Objection to Springvale water treatment plant SSD 7592 Mod11

Modification 11, consequences of the proposed consent amendments

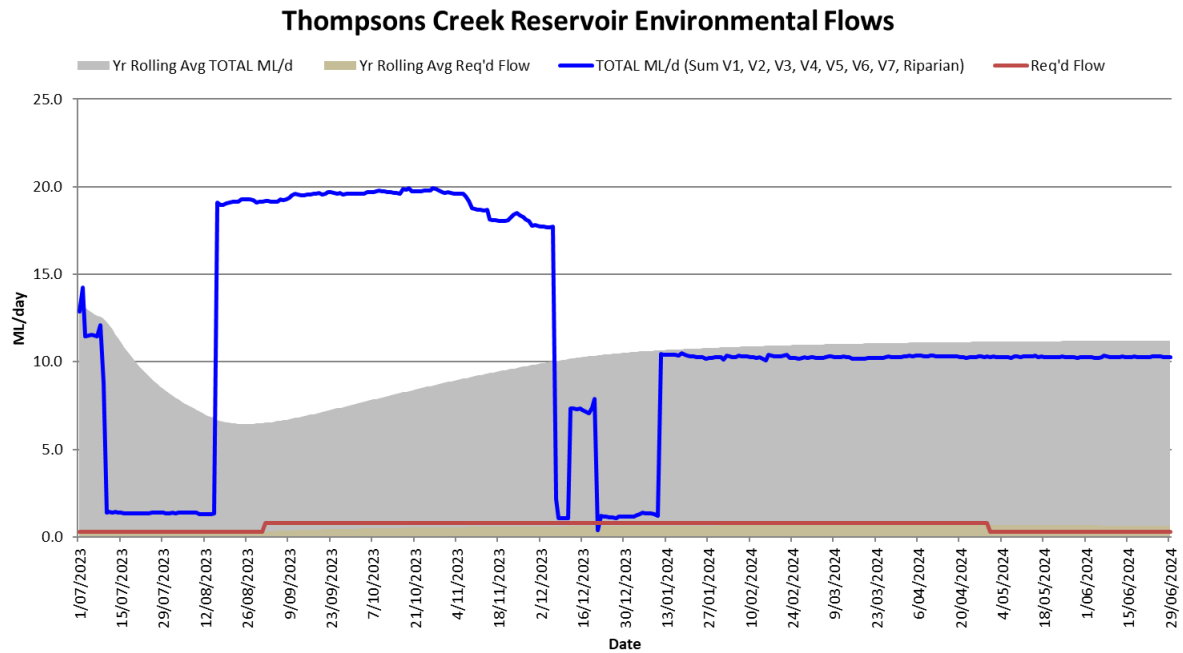
The total of partially mine waste discharged from TCR to receiving waters was **5,525ML** last financial year (based on the above averaged data) and is shown graphically below in Figure 3-1 extracted from EnergyAustralia’s compliance report:

The emergency discharge data corresponds with Environment Protection Licence No. 13007 that permitted an emergency release of 1,549.8ML and was permissible under planning consent (SSD 7592 condition 6). Thus last financial year, Centennial Coal discharged 3,975ML (3.975GL) of inadequately treated mine water into Sydney's drinking water catchment without planning consent or a pollution licence.
